Rother Valley Railway  
Non-Motorised User (NMU) Audit Report  
July 2013

Rother Valley Railway  
Non-Motorised User (NMU) Audit Report

July 2013

B.3. B2244 Junction Road – Level Crossing Details

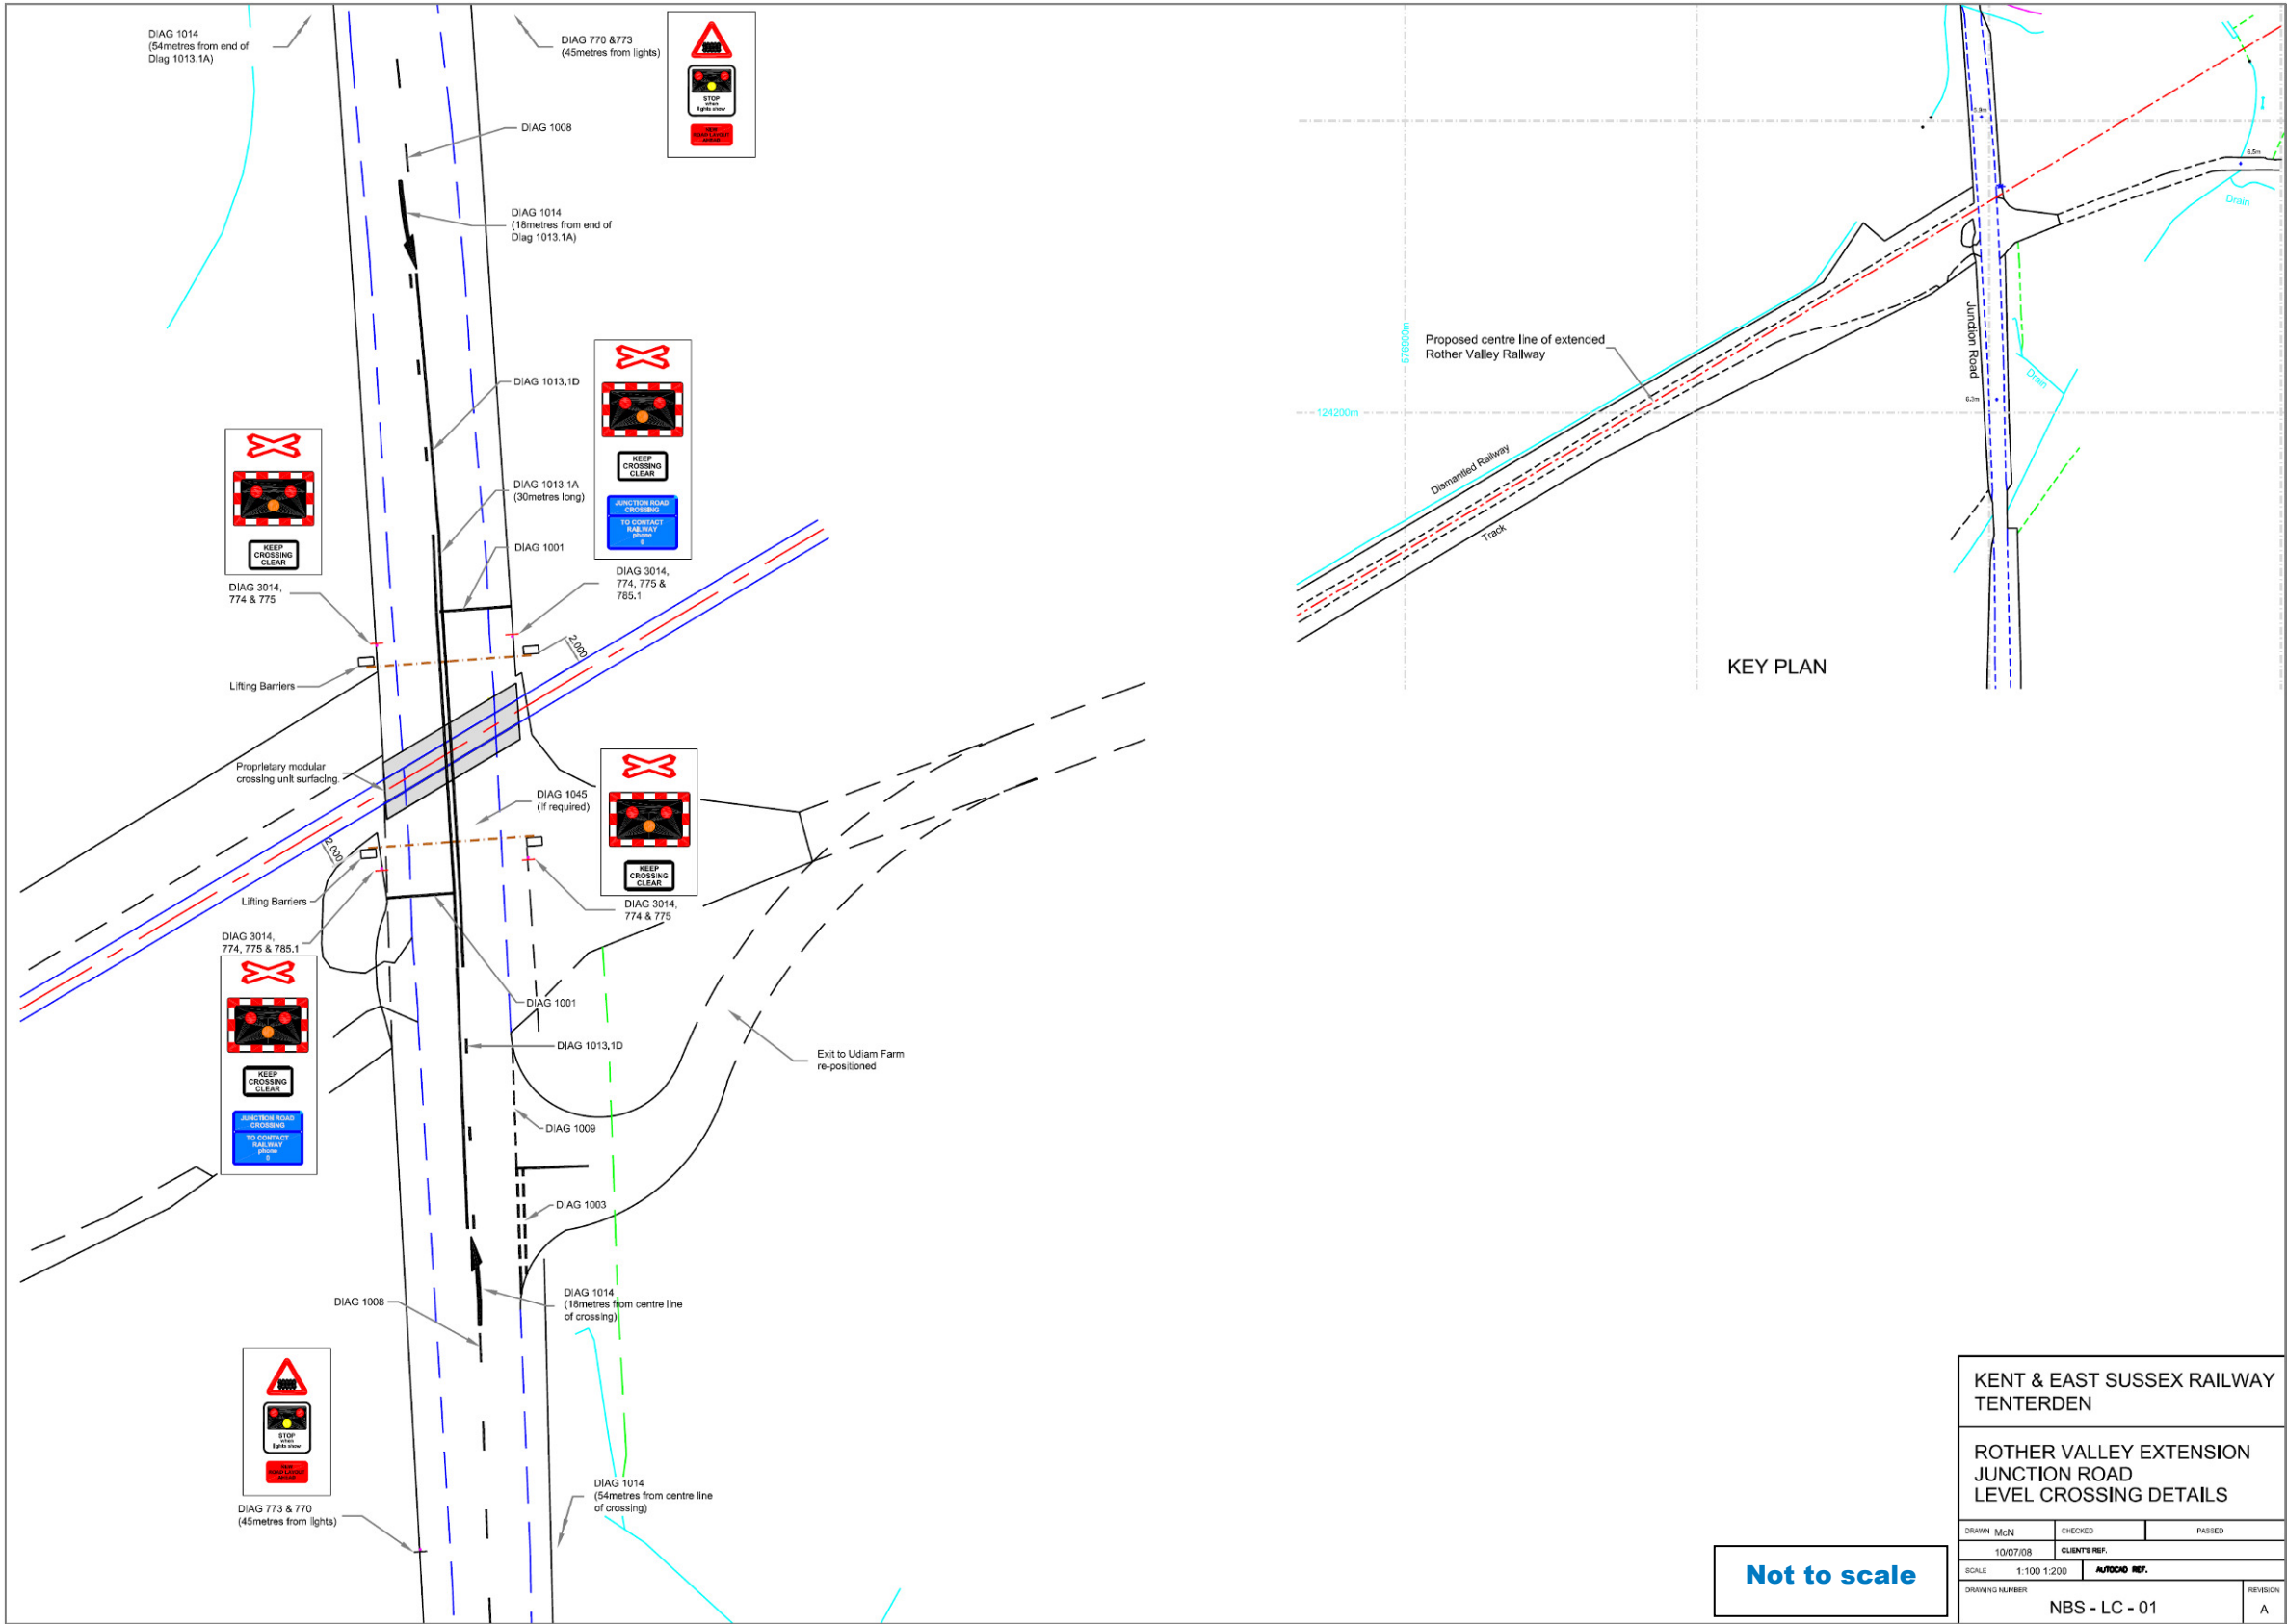
The drawings, prepared by Rother Valley Railway, show the proposed layout for each rail level crossing. These feature a full (carriageway) width barrier with the intention to prevent vehicular traffic and NMUs incurring into the level crossing.

It is unclear whether the barriers and fencing will completely prevent the risk of NMUs crossing the rail line when in operation. Any gaps between the crossing gates and the boundary fence may allow NMUs to bypass the barrier.

The barriers are being incorporated into the railway corridor fence line, preventing NMUs access across the railway when the gate is in operation.

No supplementary NMU access across the railway would be provided at the level crossing.
